Applicant: Daniel J. Dove
Serial No.: 09/939,418
Conf. No.: 4205
Filed: 08/24/2001
For: REDUCED PIN-COUNT SYSTEM
INTERFACE FOR GIGABIT ETHERNET
PHYSICAL LAYER DEVICES

**DECLARATION OF ROGER D. GREER OF PRIOR INVENTION
TO OVERCOME CITED PUBLICATION (37 C.F.R. §1.131)**

From: DOVE,DANIEL J (HP-Roseville,ex1) [dan_dove@hp.com]
Sent: Monday, August 20, 2001 2:35 PM
To: 'Roger D. Greer'; DOVE,DANIEL J (HP-Roseville,ex1)
Cc: MASON,DAVE (HP-Cupertino,ex1)
Subject: RE: 10115055-1 patent drawings.

Figure 2

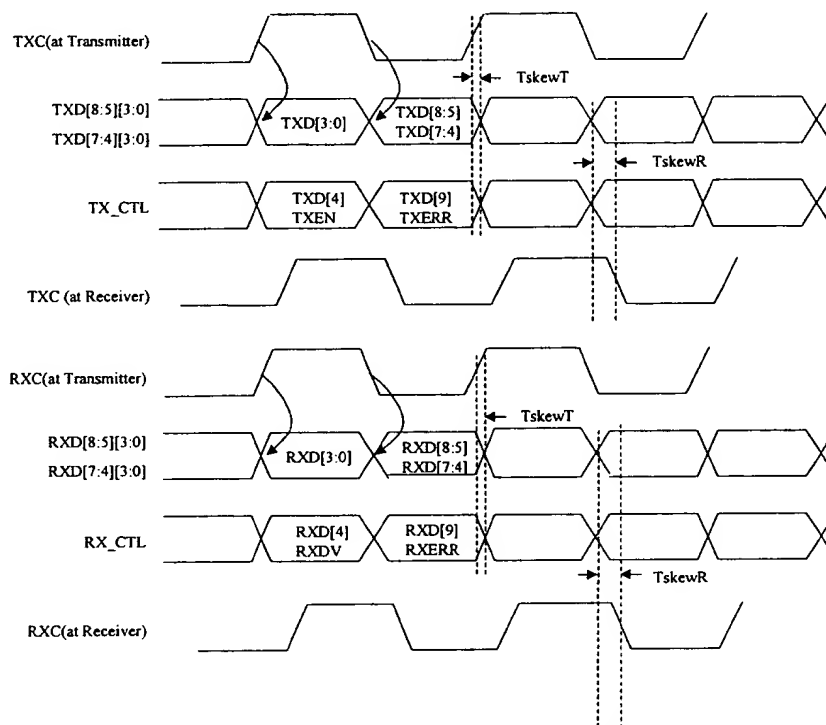
- Change TXF[B-5] to TXD[8:5] ✓
- Put TXEN above TXD4 on the next line.
- Add RXD[8:5] below RXD[7:4] in next figure down.
- Behind RGMII, put RXDV_RXERR on the next line of the lower figure
- Behind RTBI put RXD4_RXD9
- Modify the value in the cell from just RXDV to RXDV with RXD4 below it.
- Modify the value in the cell from just RXERR to RXERR with RXD9 below it.
